PROJECT: KFC
Village of Horseheads
Municipal Construction Inspection
November 15, 2019

BY: Jessica Verrigni, CPESC, CPSWQ

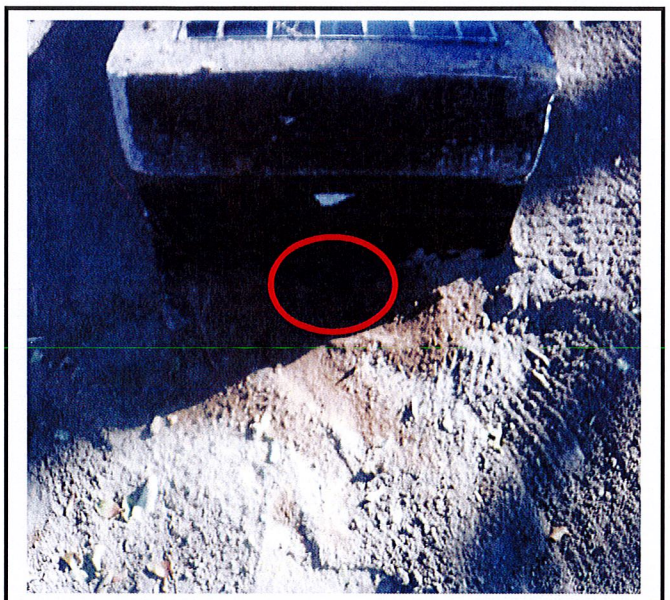
Stabilization of exposed soil is required.

Stabilization of exposed soil is required.

Pond has been graded. Stabilization is required before erosion starts.

Low flow orifice has been covered and needs to be dug back out.
